# Technical Service Bulletin

<b>Subject:</b>  FRONT AND REAR BRAKE NOISE	<b>Bulletin No.:</b> 04-004/22
	<b>Last Issued :</b> 11/29/2022

2013-2023 CX-5

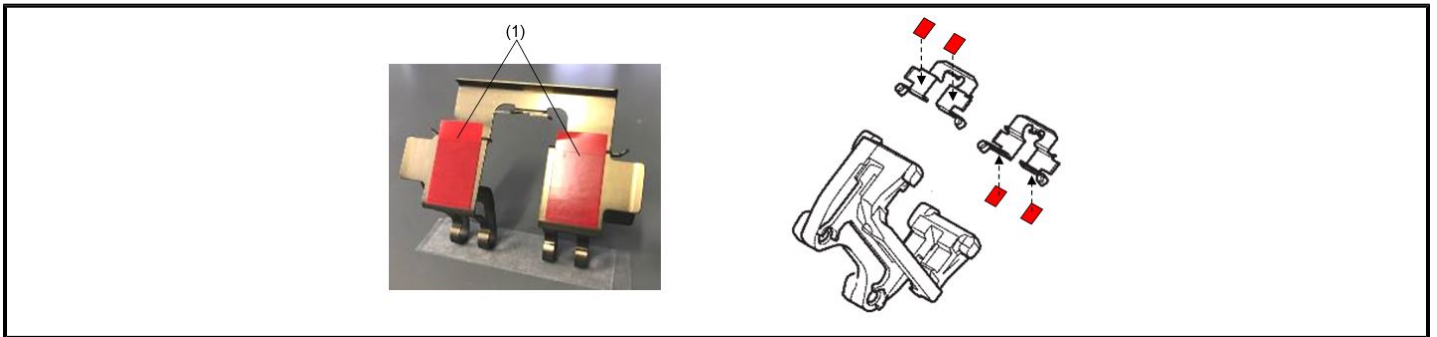
- Verify if the tape is installed to both guide plates (some kits do not have the tape installed and is packaged separately).
- If the tape is not applied to the guide plates, peel off the red release film (1) and the dual adhesive tape (2) from the release paper (3) and apply the dual adhesive tape to the contact surfaces of the guide plates as shown below.
